SEABROOK STATION  
Engineering Office

Subject: Level Measurement Error (SER Outstanding Issue No. 10)

Revised Response to RAI 420.23

420.23  
(7.2)

Figure 1 Schematic of Heat Transfer Model for Reference Leg Thermal Response

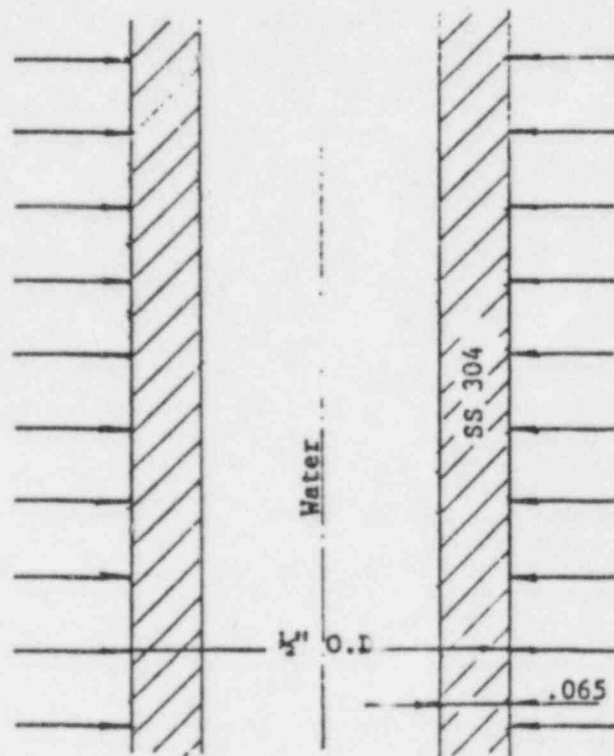
Describe how the effects of high temperatures in reference legs of steam generator and pressurizer water level measuring instruments subsequent to high energy breaks are evaluated and compensated for in determining setpoints. Identify and describe any modifications planned or taken in response to IEB 79-21. Also, describe the level measurement errors due to environmental temperature effects on other level instruments using reference legs.

- g. Containment free volume is  $2.84 \times 10^6 \text{ ft}^3$  (approximately 5% higher than that used in the DBA analysis).
- h. The reference leg response is calculated following guidelines prescribed in NUREG-0588<sup>2</sup> using the HESITET<sup>3</sup> computer program. Figure 1 is the schematic of the reference leg model.
